## COMMITTEE REPORT

BY THE DIRECTOR OF ENVIRONMENT AND NEIGHBOURHOOD SERVICES  
READING BOROUGH COUNCIL  
PLANNING APPLICATIONS COMMITTEE: 8<sup>th</sup> JANUARY 2017

Address: Green Park Village, Longwater Avenue

Proposal: Application for approval of reserved matters following outline approval for Phase 2C for 30 dwellings and A class retail uses (ground floor) (10/01461/OUT)

## Elevations

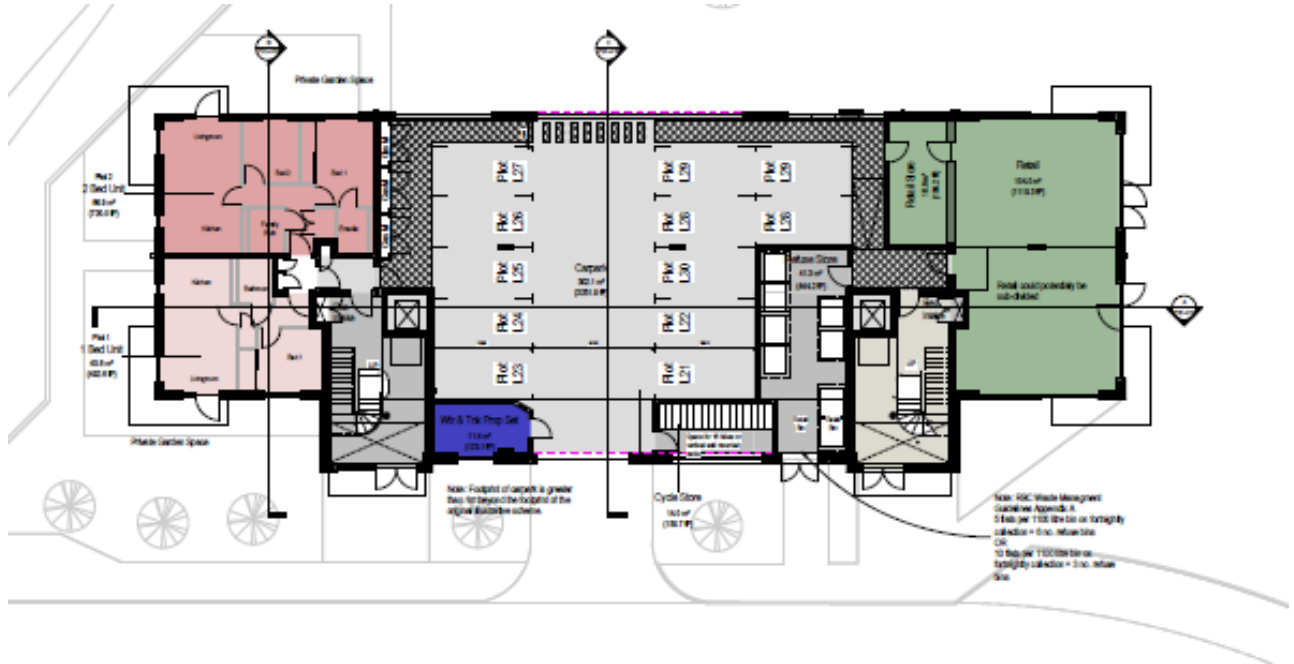
- 6.10 Although this is a departure from the original outline consent it should be considered within the context of surrounding buildings. Those around the "Market Square" are between four and six storeys and when viewed in section form, this building, which sits just north of the 6 storey Extra Care building reflects the rise and massing from the longer views across the site. Notwithstanding that the scale is considered to fit within the context of the surrounding buildings the mass of the building has been reduced through the stepping in of the fourth floor. This in itself is similar to the design and scale of the urban house type to the north.

- 6.15 Visual interest is created through the massing and articulation of the building along with detailing of the facades, which adds relief. At ground level the brickwork has been enhanced with the introduction of linear projecting stretcher courses, which provide texture and highlights the key areas of the building around the retail units and building entrance cores. The brick proposed here is intended to be a buff colour with a rough face and deep set joints, similar to that used for the Extra Care building. Above ground level there are textured grey panels alongside window openings and at the top floor and main entrances heavily textured vertical panels with a profiled finish as also being used on the Extra Care Building.
